Weber County Planning Division

Amended Site Plan Administrative Approval

Site Plan Name: Snowbasin Parking Lot (Terrace A) Lighting
Date Submitted: July 11, 2011
Land Serial Number: 20-043-0005
Approximate Address: 3925 East Snowbasin Road
Planning Division Staff Review: Scott Mendoza

MAIN PARKING LOT
LIGHTING PLAN &
PHOTOMETRICS

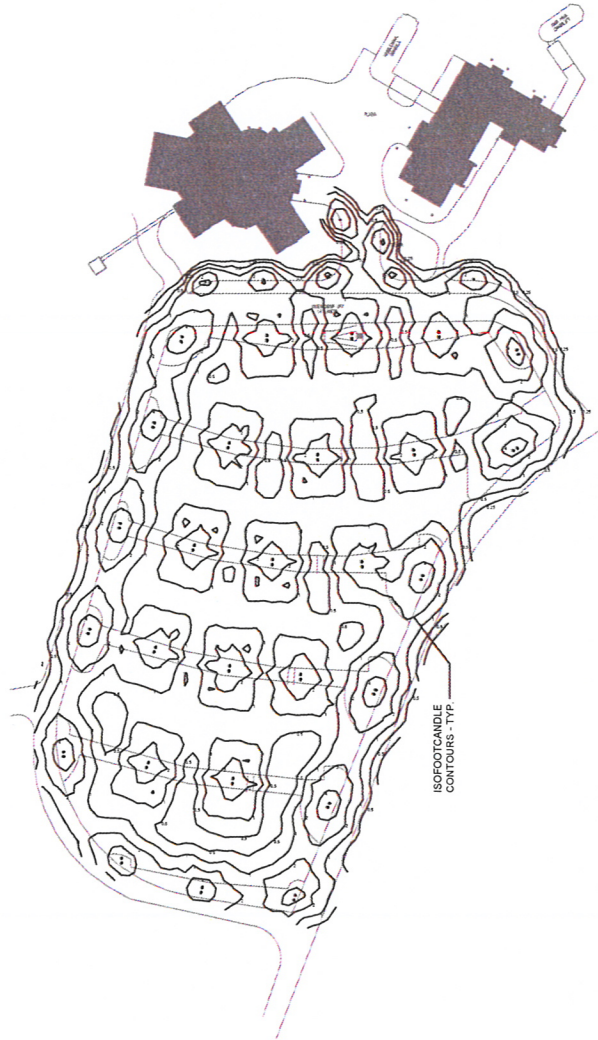
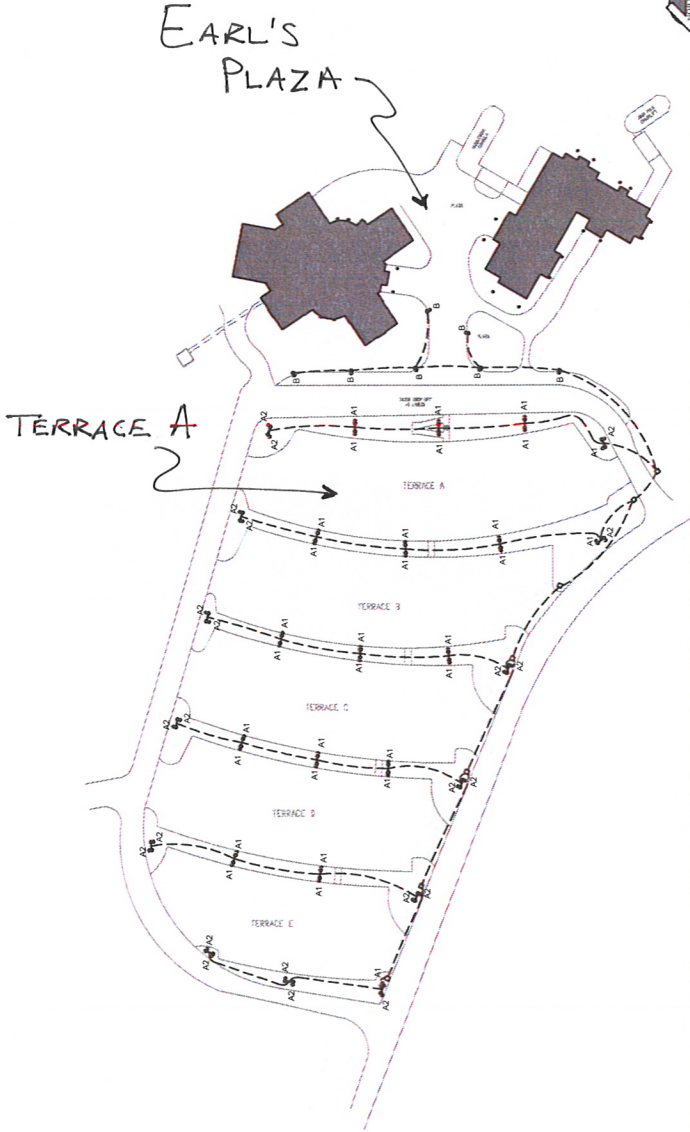
The proposed amendment to the site plan involves a lighting plan and subsequent installation of seventeen light fixtures which are intended to provide nighttime "event" lighting in the Earl's Lodge Plaza and Terrace A of the upper parking lot only. Seven of the fixtures will be located in the Plaza, have a maximum height of twelve feet and house one lamp. The remaining ten fixtures have a maximum height of twenty-five feet, will house two lamps (on opposing sides) and will be located on the periphery of Terrace A as stated above. See Exhibit A for fixture placement and photometric distribution.

- Use of a permitted high pressure sodium (HPS) light source.
 - Use of an appropriate shielding devise.
 - Filtering is not required.
 - Location and use of a fixture and light source that will not emit light to or beyond any property line.

EXHIBIT B

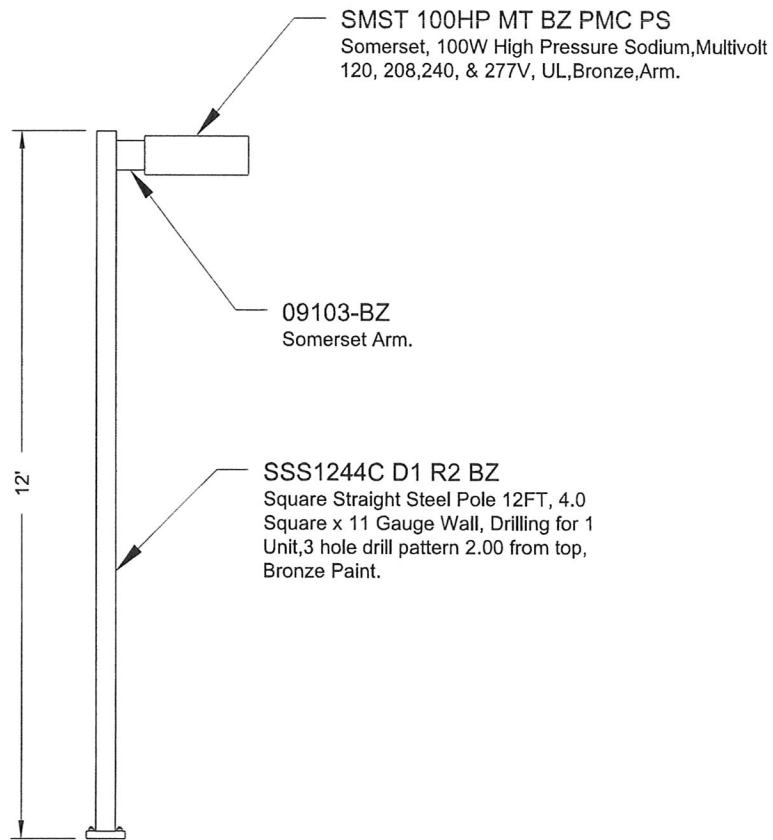
The fixtures, according to the application, have a contemporary design, are finished in a dark bronze color, and are constructed of heavy duty, cast aluminum which forms each fixture's post, arm(s), and lamp housing. See Exhibits B, C, and D for the fixture illustrations and dimensional details.

- Chapter 18C requires that all exposed metal materials are painted, stained, or anodized in a manner that leaves a non-reflective, natural, and muted earth-tone color. The proposed light fixtures will be finished in a dark bronze color which meets this requirement.
